**Albuquerque
Metropolitan
Arroyo
Flood
Control
Authority**

Re: Parkway Subdivision Unit 10
 AMAFCA Field Visit

Re: Grading & Drainage Plan for Parkway, Unit 10 Subdivision, ZAP J-9
Engineer's Stamp Dated January 19, 2004

Re: Parkway Unit 10 Grading & Drainage Plan, Engineer's stamp dated 6-25-02 (J9/D17)

PRELIMINARY PLAT

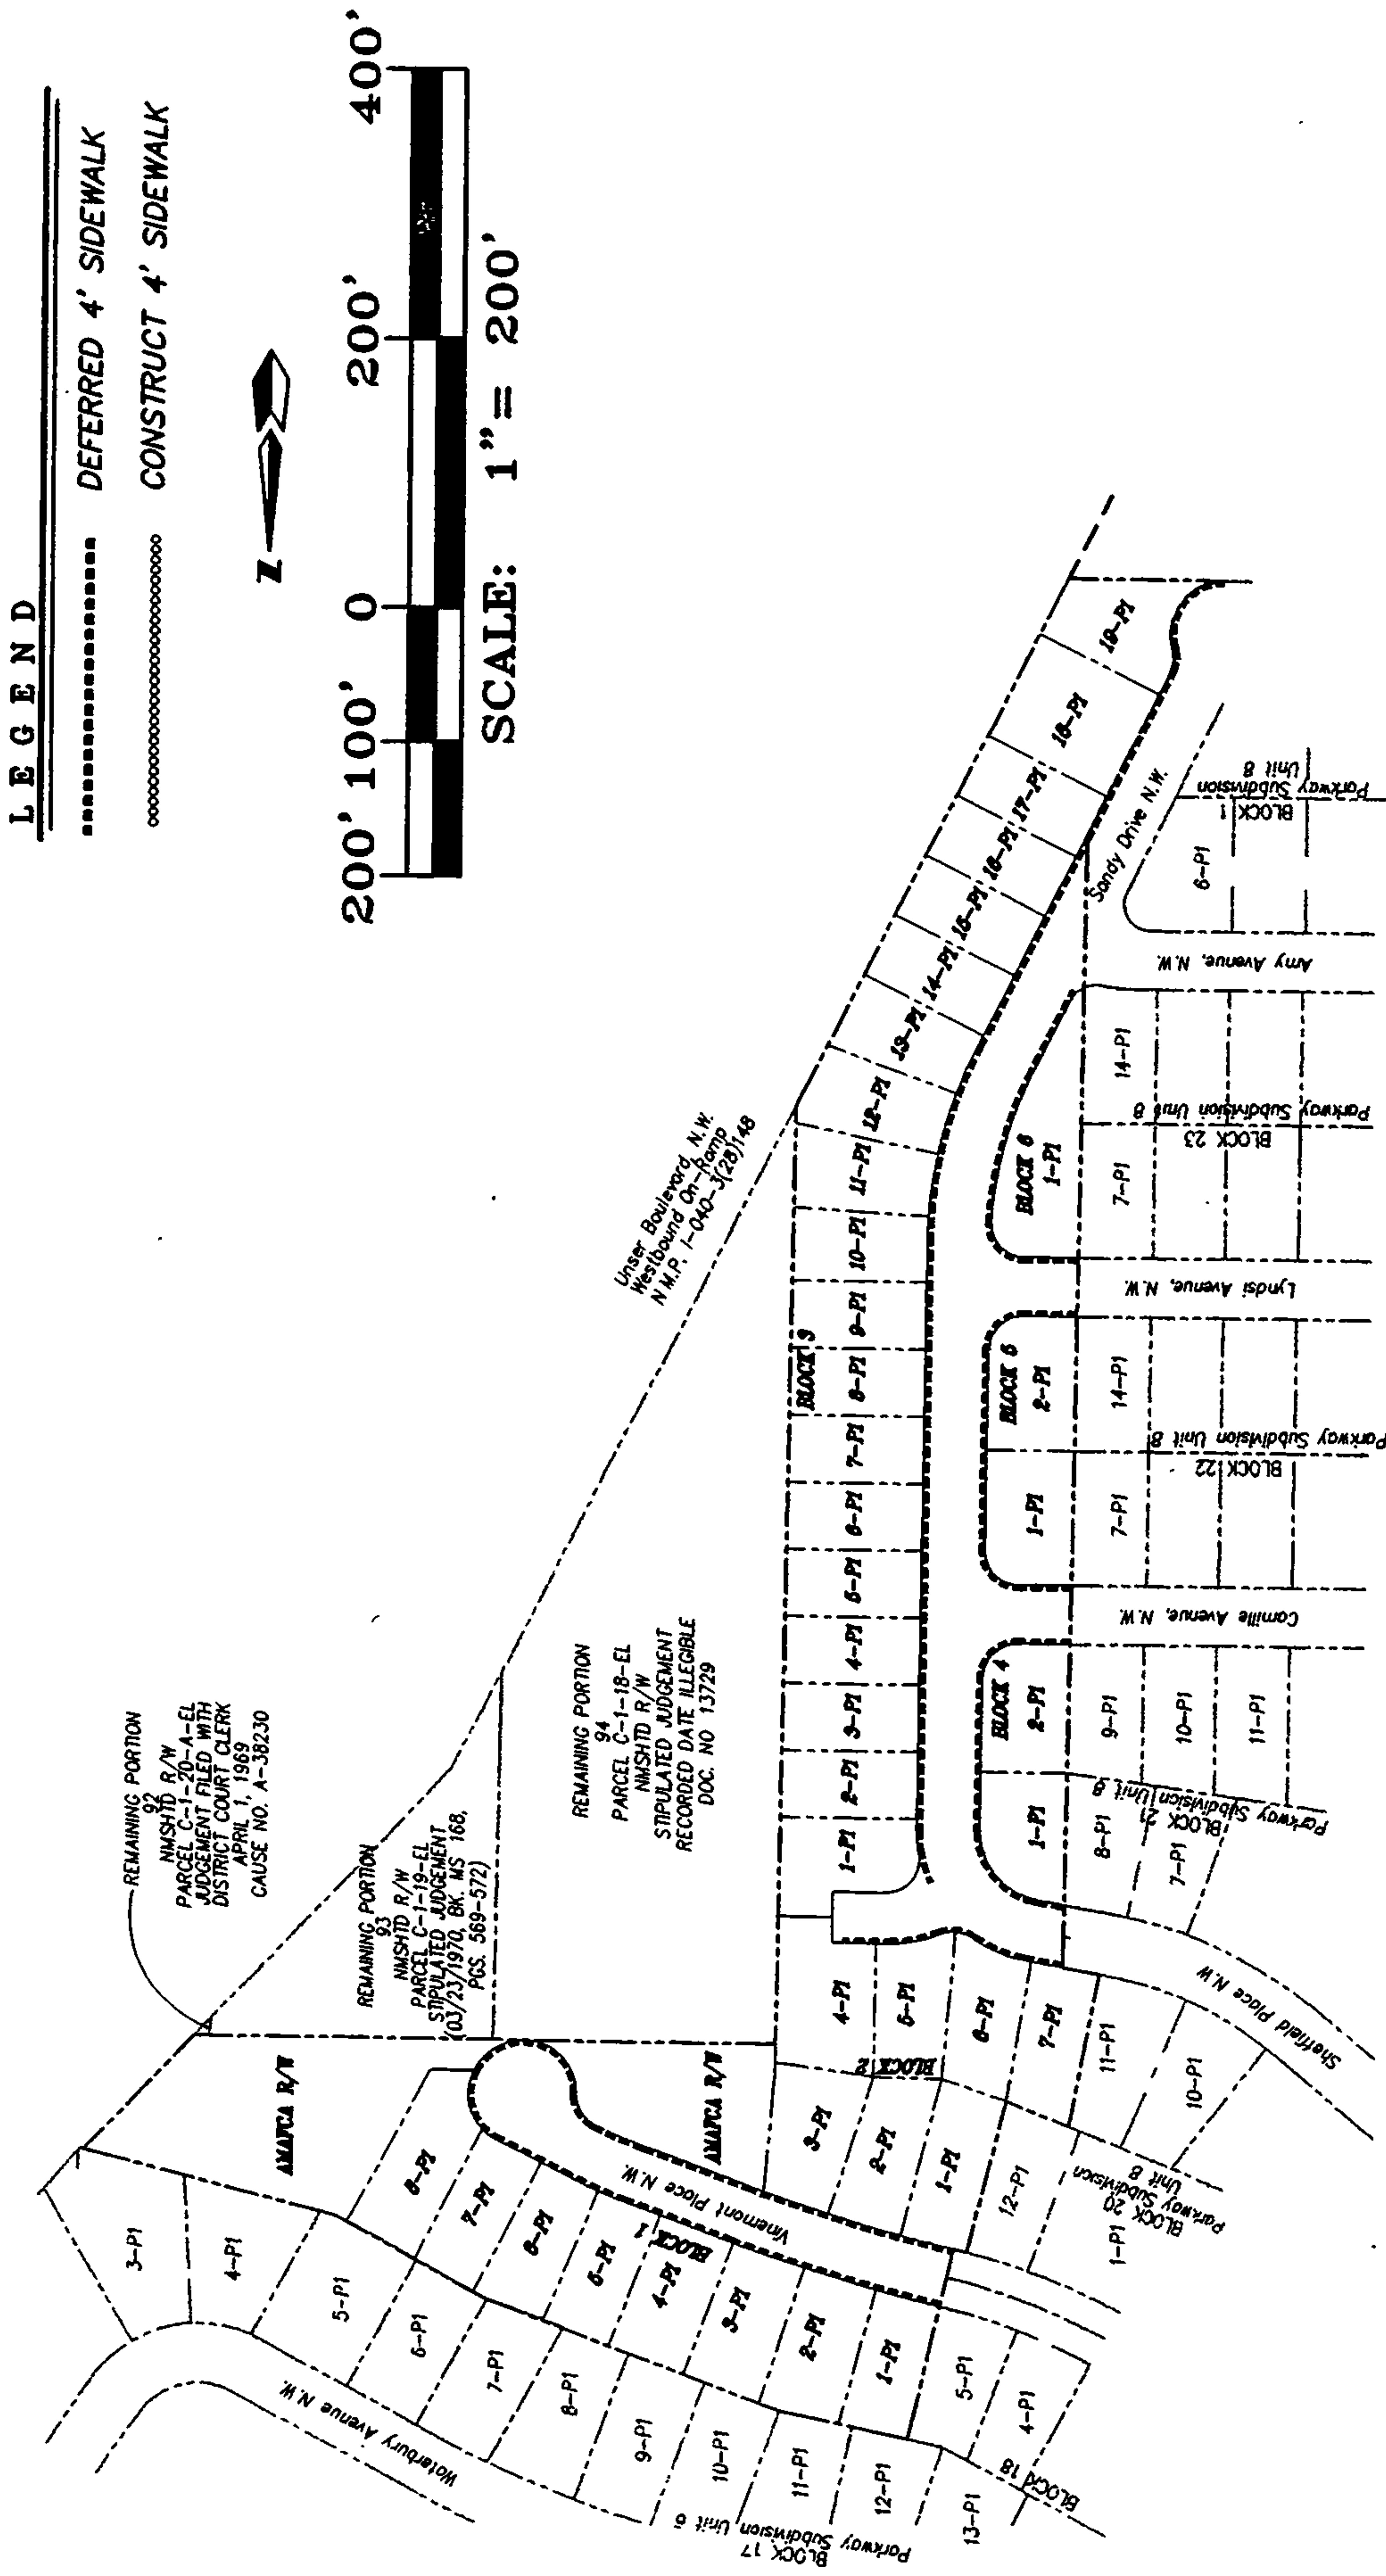
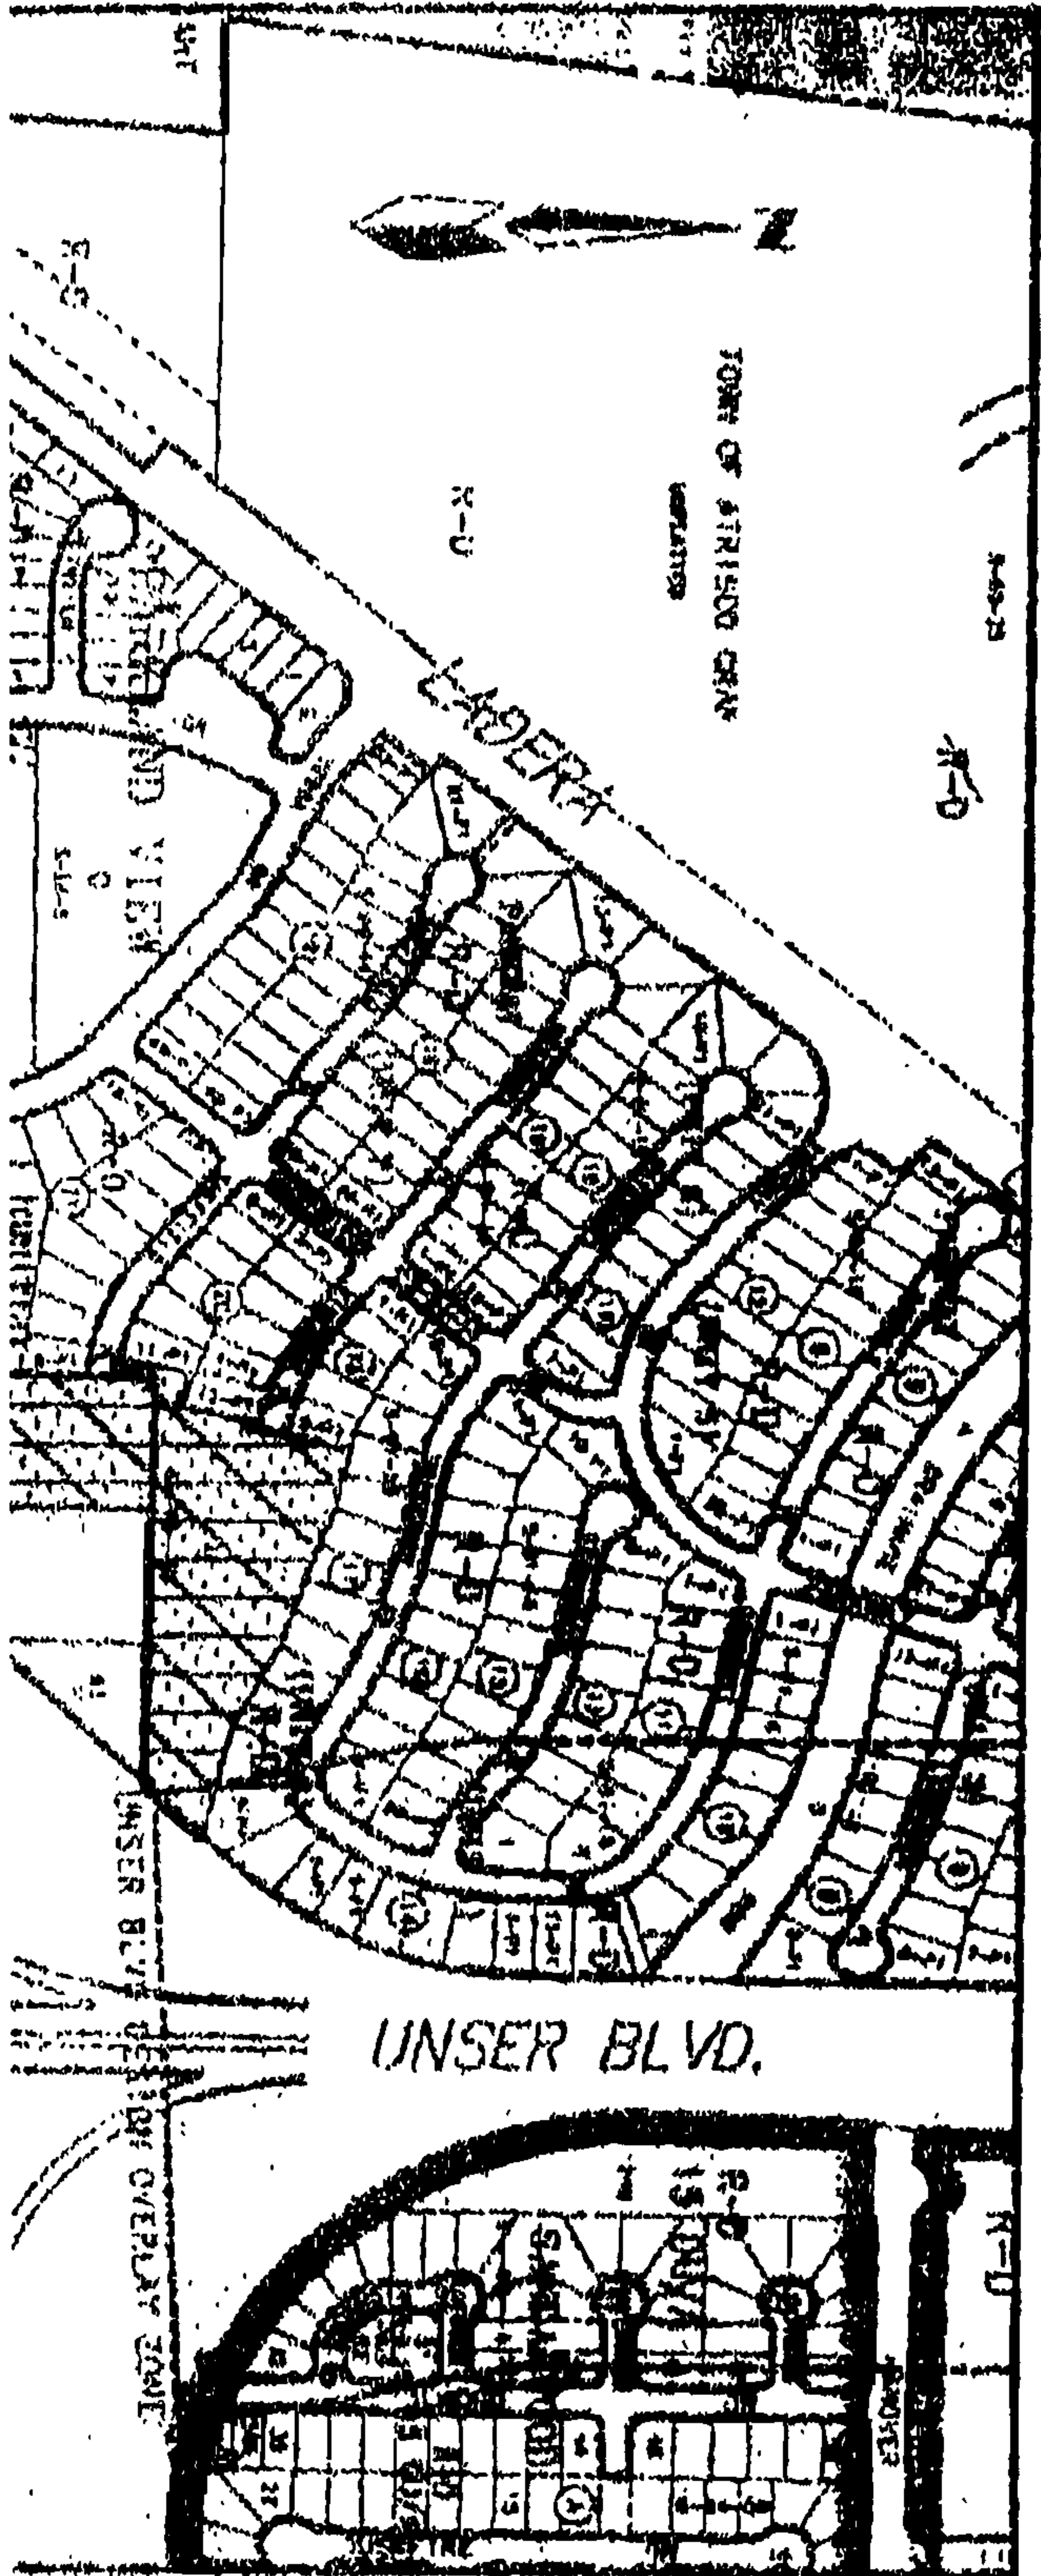
NANCY, FYI - JOHN KELLY SIGNED THIS PLAT AS OWNER
OF TRACTS "A" + "B" AFTER THEY AGREED TO
ADD THIS NOTE. HOWEVER, WE NEVER RECEIVED
THE G&D PLAN. Jmz

* "AMAFCA has executed this plat as owner of Tracts AMAFCA ROW "A" and AMAFCA ROW "B" in order that Westland Development Company may proceed with the development process for its property shown on this Preliminary Plat. Before Westland can develop its property shown on this Preliminary Plat, and before Westland can vacate the easements it proposes to vacate with final plat approval, significant downstream drainage infrastructure is required. The execution of this plat by AMAFCA as owner of Tracts AMAFCA ROW "A" and AMAFCA ROW "B" in no way implies that AMAFCA has approved Westland's plans or the vacation of various easements shown on this Preliminary Plat. A Grading and Drainage Plan will be required to be submitted to AMAFCA and the City of Albuquerque for review and approval."
